MEMORANDUM

FILE NO: RM120928V2, RM190790 (land use), RM190789 (Subdivision), RM190791 (Land disturbance) and RM191308 (Water permit) - Integrity Care Group Ltd

RE: **Integrity Care Group Ltd – Provision of Reserves**

To: Jennifer Lancashire - Consent Planner
From: Dugald Ley - Development Engineer
Date: Nov 2020
File no: RM190790 and RM120928V2
Re: **Integrity Care Group (Olive Estate), Development / Care facility extension through to Hill Street - Engineering Infrastructure**

Figure 2 – Plan submitted with the further information

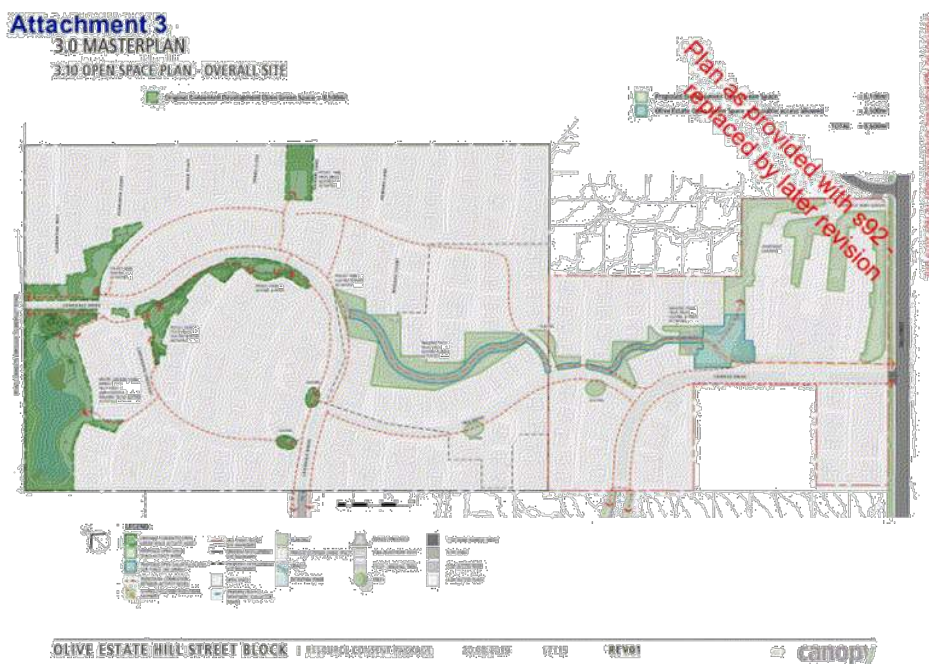
The applicant provided the plans (20 August 2019) shown in Figure 2 below and noted the areas the Applicant proposed to make available for public use. This included the shared path within the green corridor from the open space area adjacent to the care facility. The Applicant noted that this would provide a combined total area of publicly available open space of 2,500m².

While the application states that the land shown in Figure 5 above would be available for public use by way of a volunteered condition on the land use consent and a covenant on the title is acknowledged, it is subject to the following conditions:

This is an unconventional approach that has not been proposed before and we can see no compelling reason for Council to accept it as it would not guarantee unrestricted public access, would be developed, managed and maintained by a third party, but would require that Council offset reserve financial contributions. In addition, from a general reserves design and management perspective, the proposed ownership/ management structure, location and design may result in an area that does not look or feel like a public reserve – rather an open space for Integrity Care residents next to the care facility.

Our recommendation has, and continues to be, that a visible and accessible recreation reserve of 2,000 – 2,500m² vest at the intersection of Fairrose and Iris Drive. This would provide an area that is visible and accessible and managed in a manner that looks and feels like a public recreation reserve not an accessory open space area to the care facility.

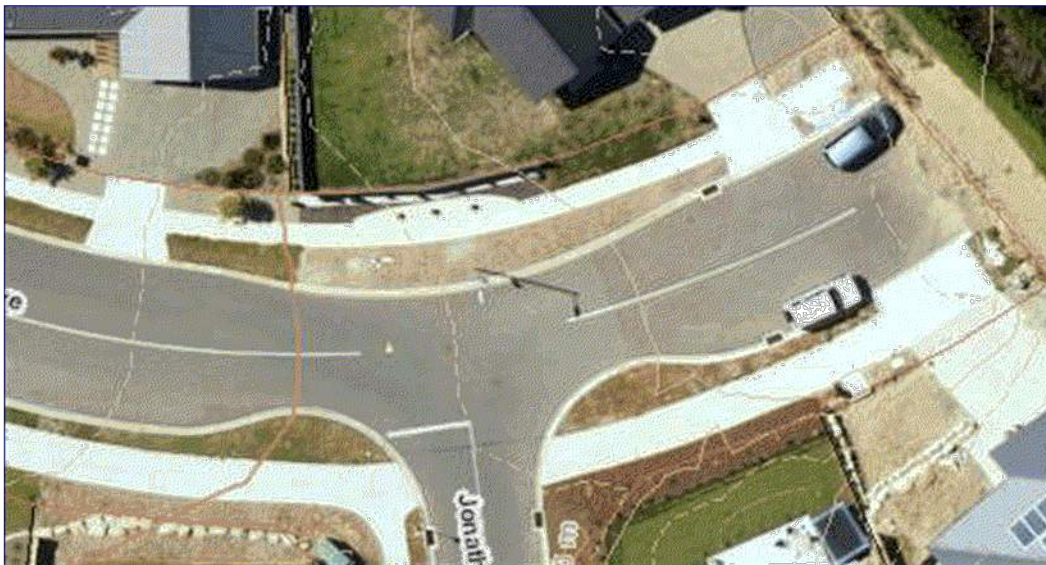
Council has refined its road design standards (since the first stages of Olive Estate were established), acknowledging the slower speed environments now expected in residential areas, consequently the last section of Fairose Drive had the design elements as in the table above (green). See aerial below for Fairose Drive adjacent to the application site, LHS below.

Aerial Photo below of East end of Fairose Drive

It is noted that the wider 2.5m shared path link (bottom of photo), provides off road shared/access down to the reserve and future commercial areas at Three Brothers corner (SH6 and 60). It also shows kerb build outs (at the intersections) to slow vehicle speeds and (indented car parking).

Plan of existing Olive Estate road (green) and TRMP Indicative road (pink)

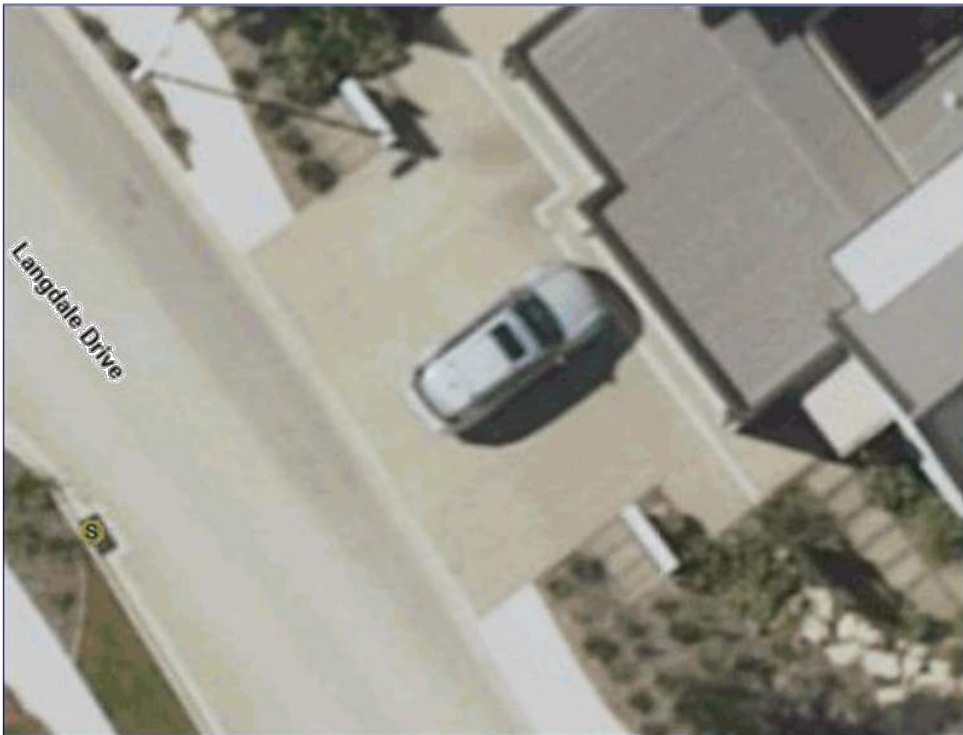
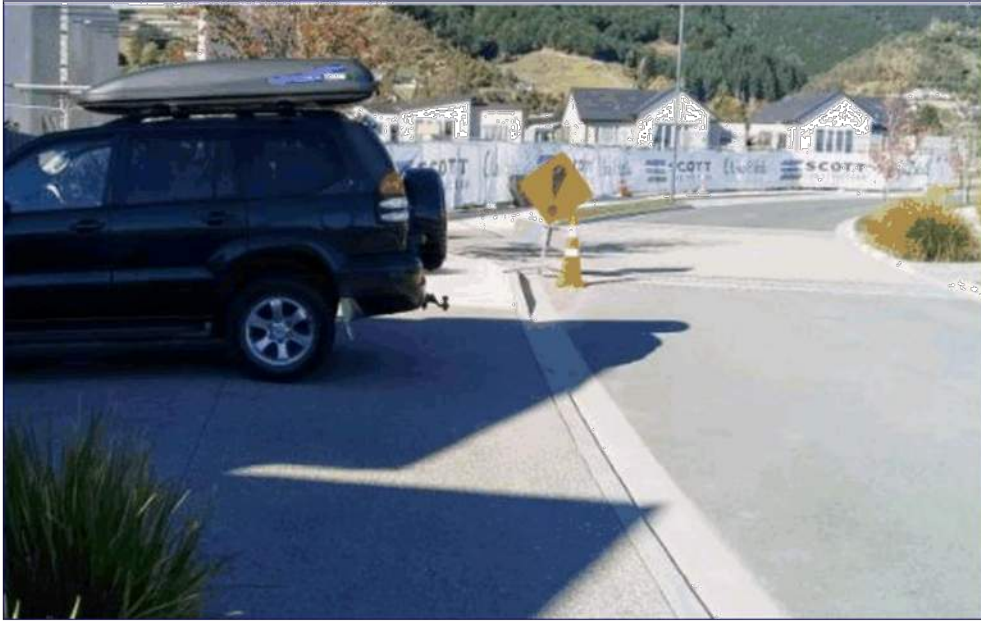
The applicant in that part of the complex has chosen to extend/lengthen Langdale Drive-green line below (as compared to the indicative road alignment shown on the TRMP planning maps-pink below) which will increase time and travel cost and encourage adjacent Fairrose Rd residential traffic to access their properties by either Hill street and or Hart Rd.

What Council officers have found was, is that this narrower road design achieves a slower speed environment, but the proximity of the garage doors to the footpaths and road has created concerns as vehicles are parking over the footpath as noted below. This forces walkers and mobility scooters onto the road and potential for conflicts with moving vehicles.

It is noted on the latest plan, villa 18 and Townhouse 1 to 11 may cause issues similar with reduced setbacks between the garage doors and footpaths. It is therefore important that the TRMP setback rule of 5.5m from the garage door to the legal road boundary is adhered to in any resource consent condition.

Fairrose Dr concept drawings

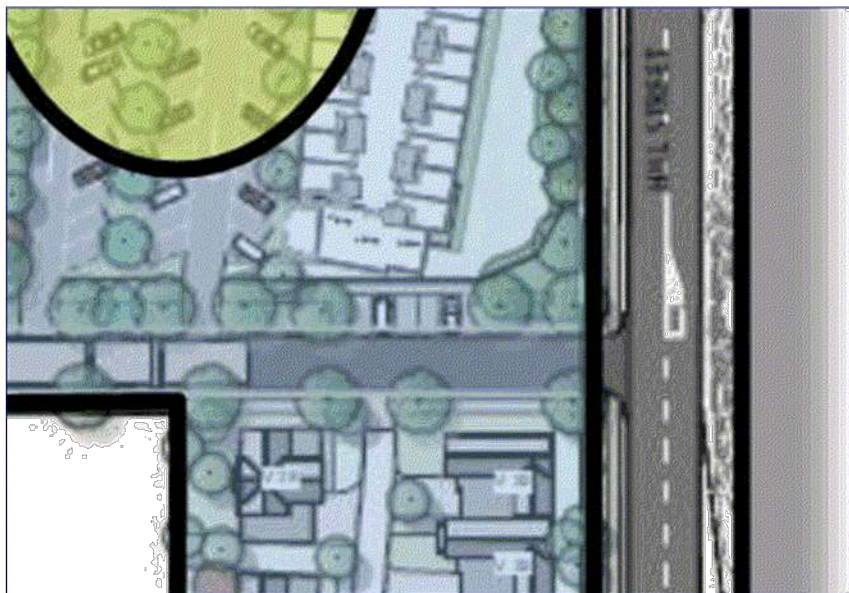
The applicant, has shown a 6m carriageway (to include moving lanes), 2 footpaths within a road reserve width of 15.5m, (It is assumed the "streetscape planting" will also be located within the road to vest) (Noting the existing portion of Fairrose Drive has a legal road reserve width of 19m).

Council staff have endeavoured to clarify the road to vest areas and widths. The road to vest area is shown on the applicants subdivision plan (below, from the applicant). However the applicant has not confirmed the width of the road reserve and this needs to be clarified. Ideally this should be 19m as per the table above.
